Docket Number:	09-AFC-05C
Project Title:	Abengoa Mojave Compliance
TN #:	232687
Document Title:	COMP14-06-00 Carbon Adsorption System Improvement
Description:	COMP14-06-00 Carbon Adsorption System Improvement
Filer:	Jose Manuel Bravo Romero
Organization:	Mojave Solar Project
Submitter Role:	Applicant
Submission Date:	4/7/2020 11:52:20 AM
Docketed Date:	4/7/2020

Petition to Amend

COMPLIANCE 14-06-00 Carbon Adsorption System
Improvement

Basis Of Design For Improved Carbon Bed System

(2 SETS REQ'RD)

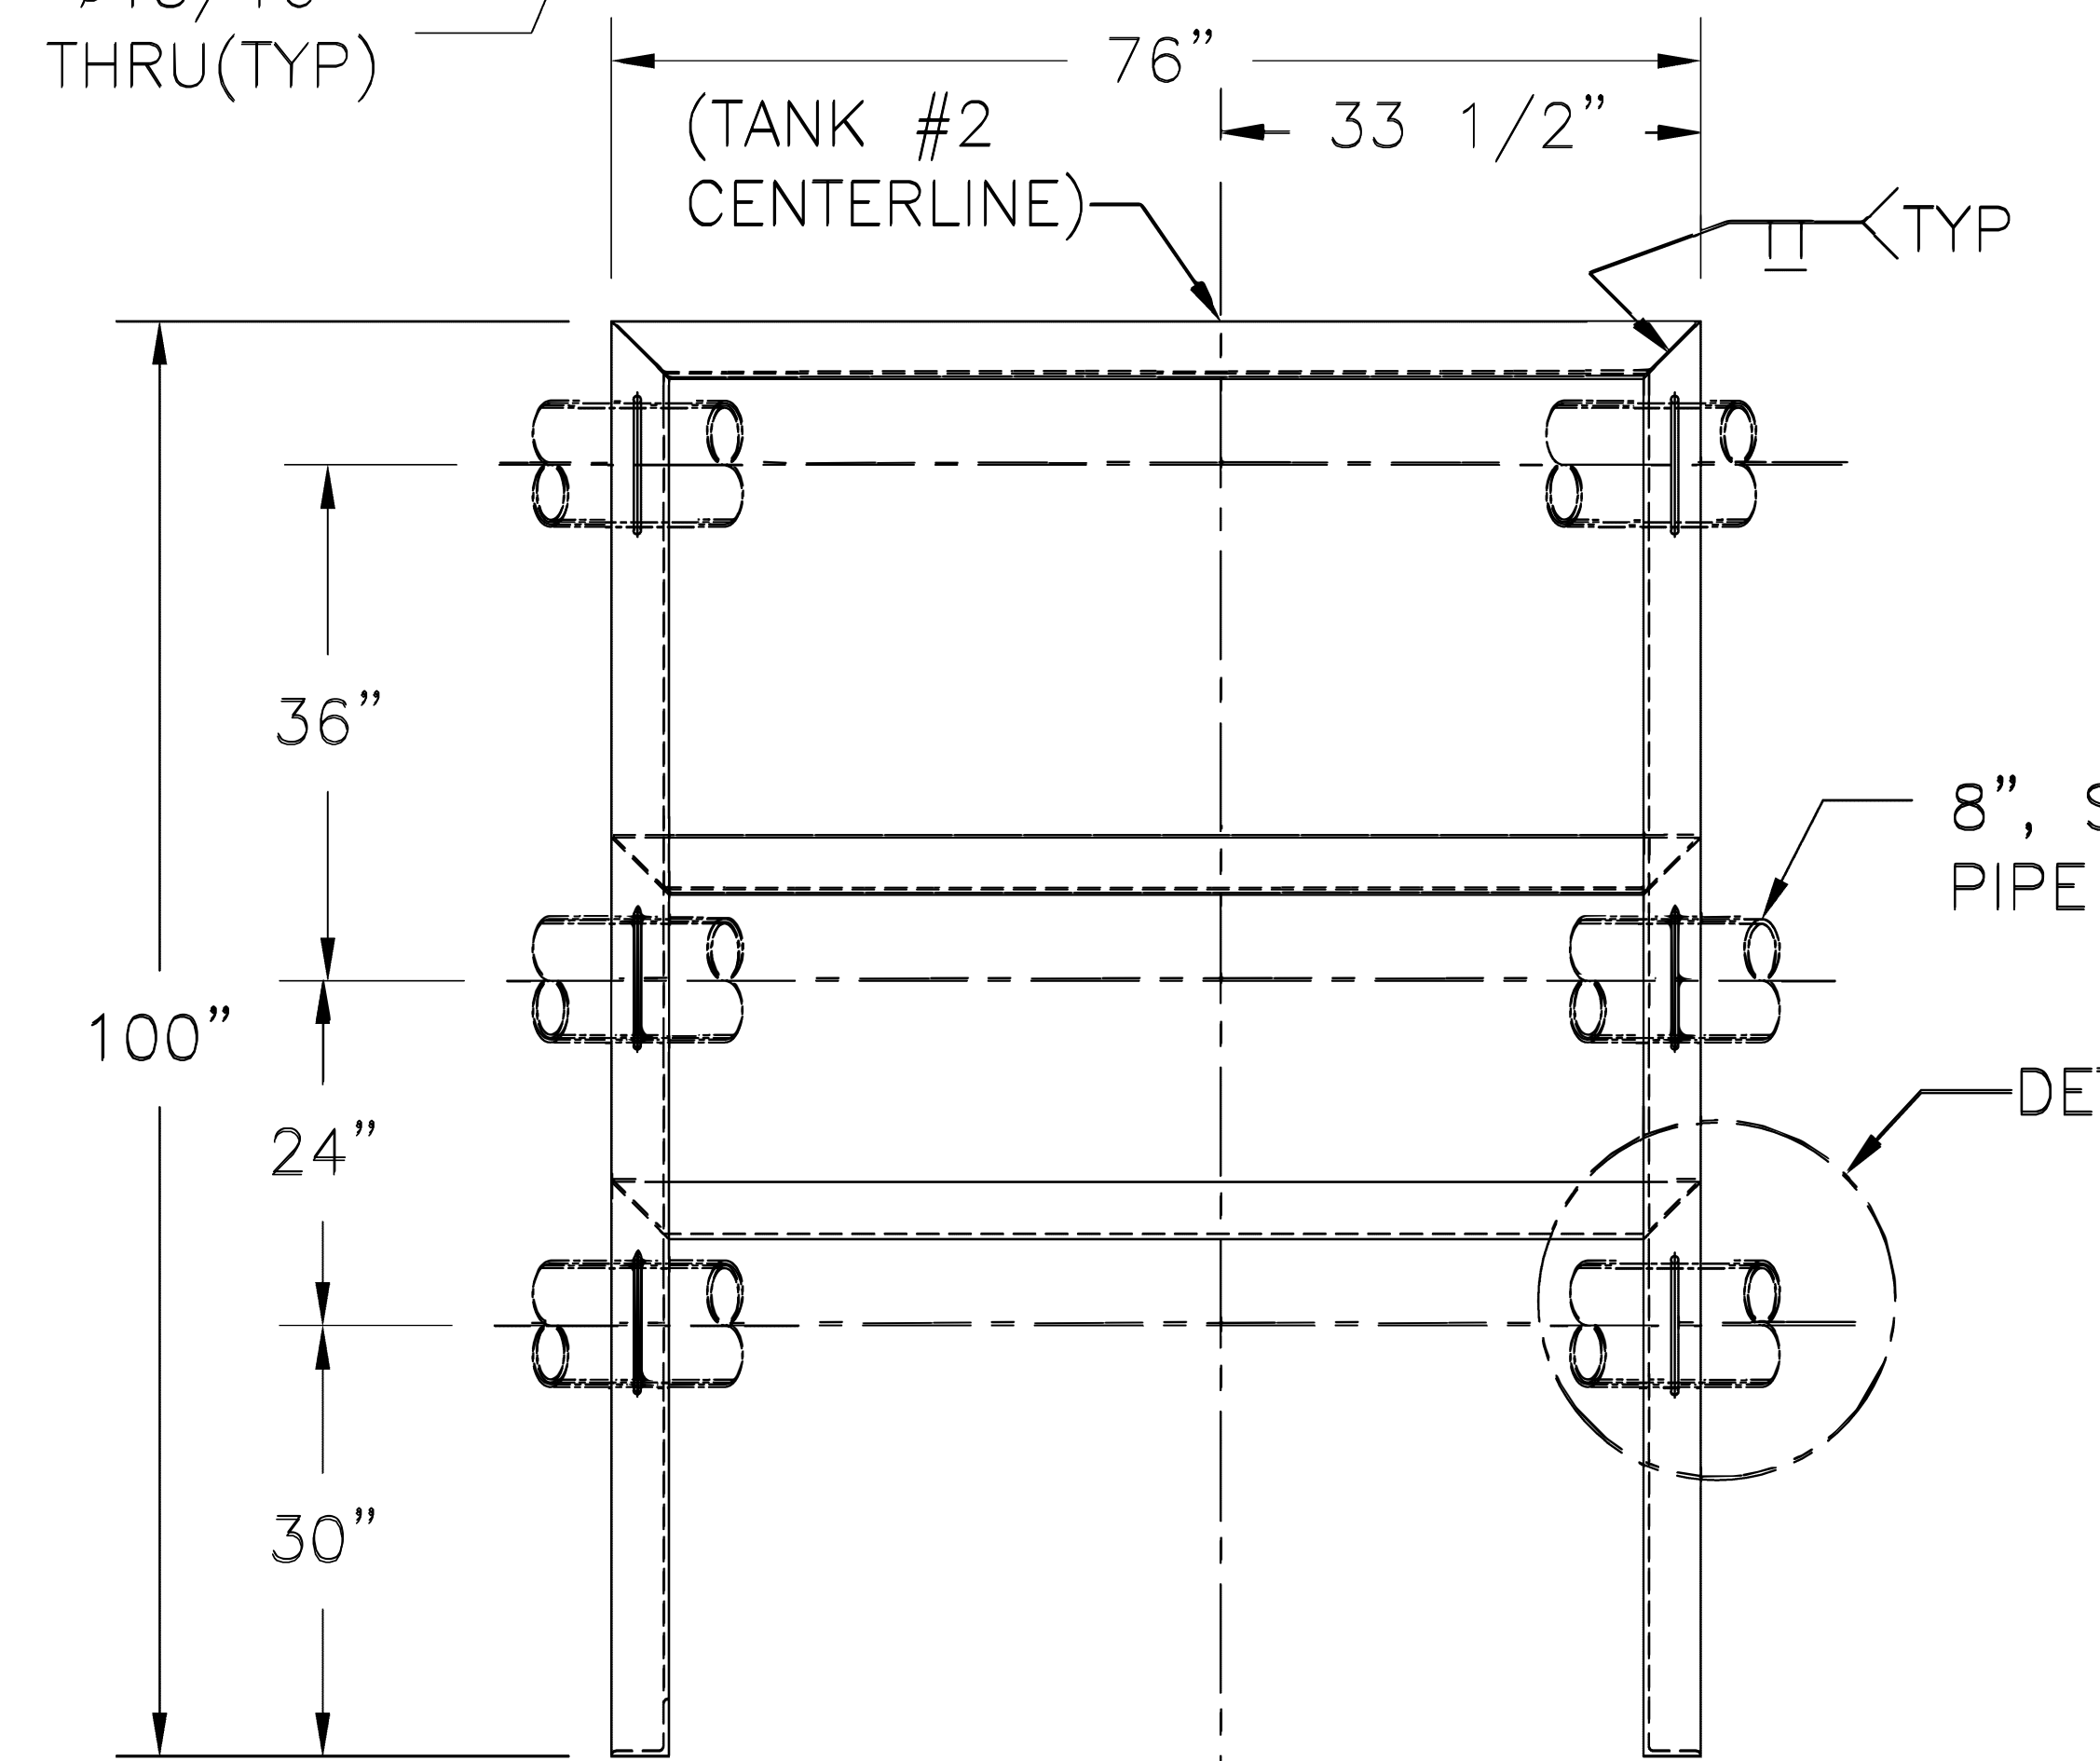
Carbon supply Inc recommends carbon bed system that can provide vertical flow orientation. The proposed canisters will include a flat activated carbon bed support across the entire cross-sectional area as well as a plenum area below this support for effective air distribution across the bed. In order to handle a wide range of flows and VOC concentrations, the systems will include three vessels that can be used one at a time, operated in parallel, or in series. The three canisters will be interconnected using a pipe rack system that allows the vessels to operate in series, lead lag, or single vessel. For the high-pressure system, each carbon bed is designed to contain 3,000 lbs. of activated carbon media. The low-pressure system will also consist of three carbon beds and each will contain 1,000 lbs. of carbon media.
